**BD700-1A10, BD700-1A11
NLG SHOCK STRUT ASSEMBLY
REMOVAL OF A SECTION OF THE SHRINKABLE TUBING**

1285A-32-06

LANDING GEAR - NLG STRUT ASSY PNR 22175-10X (Liebherr
PNR 1285A0000-0X) - Harmonization of Shrink Sleeve Design

IN-SERVICE REWORK OF THE STEERING ACTUATOR
Figure 1

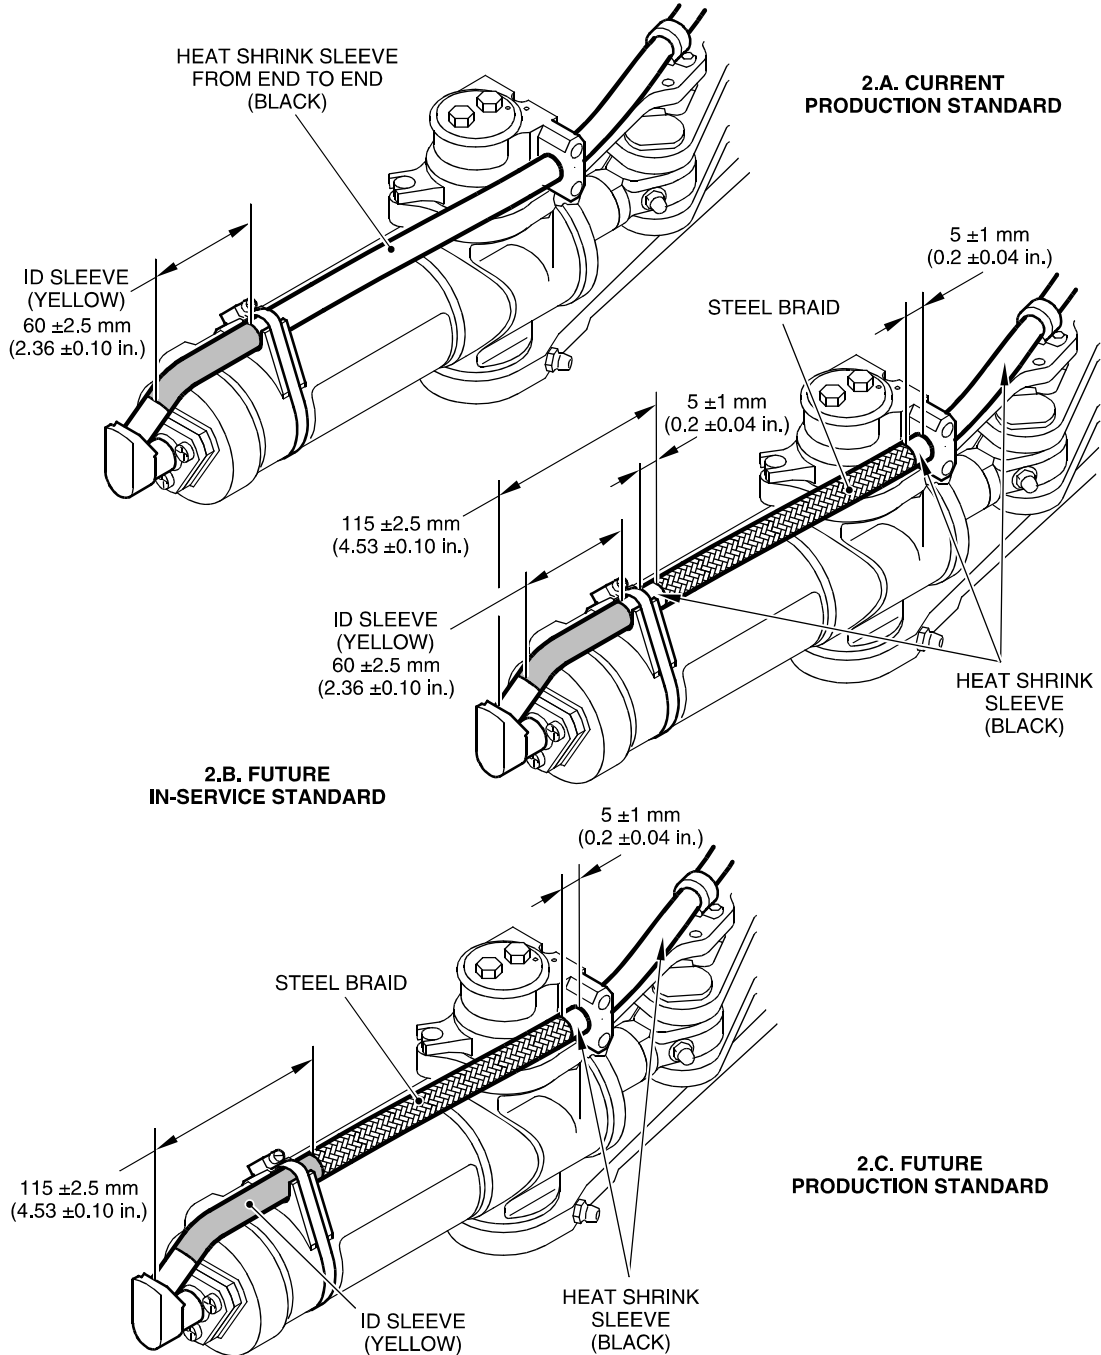
NOTE: The procedure can be done on aircraft or in the repair shop. It has to be done for the two Steering Actuators PNR 1287A0000-0X (LH) and PNR 1288A0000-0X (RH). Refer to Figure 1 of this Service Bulletin, to the LIEBHERR-AEROSPACE and Messier-Dowty CMMs 32-21-01 and 32-51-25 for a repair in the shop and to the Messier-Dowty SB700-32-032 for a repair on aircraft.

REPAIR PROCEDURE
Figure 3

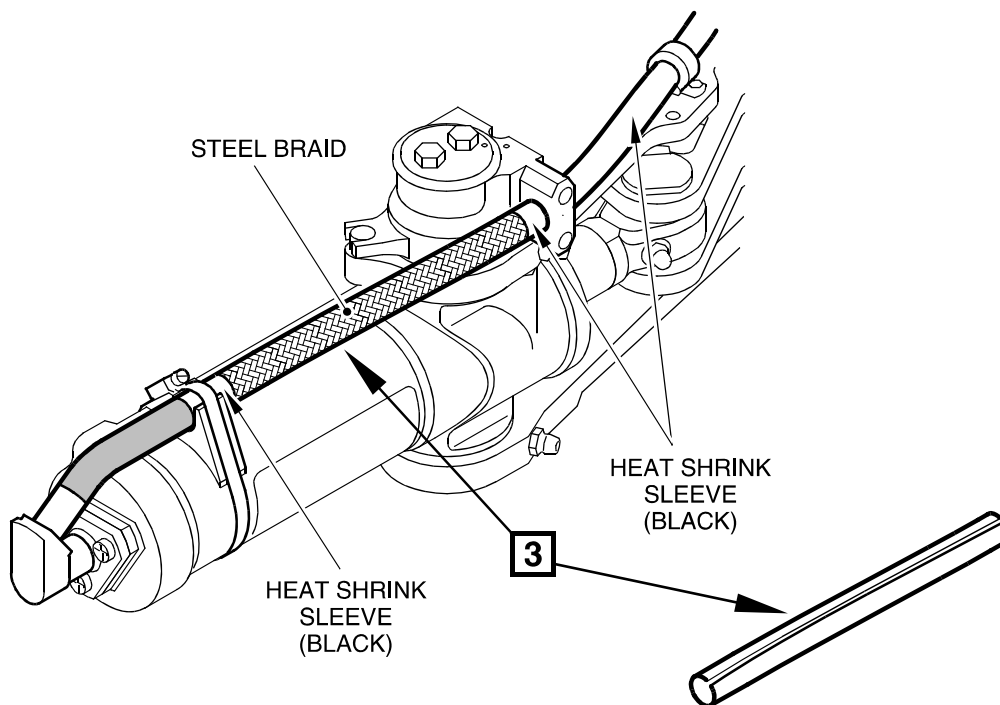
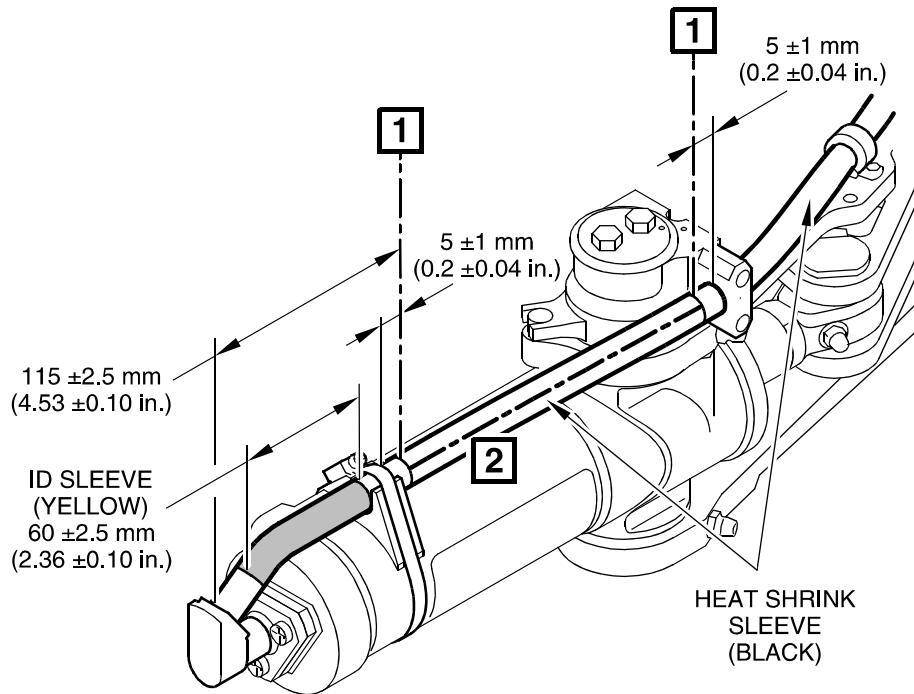
(2) Refer to Figure 3 of this Service Bulletin. Use a sharp knife or scalpel to carefully remove the black heat shrink sleeve in the affected area between the clamp and the bracket at a distance of 5 ± 1 mm (0.2 ± 0.04 in).

Cut in circular direction at a distance of 5 ± 1 mm (0.2 ± 0.04 in) of the clamp and of the bracket.

Cut in longitudinal direction between the two cuts.

Remove the heat shrink sleeve.
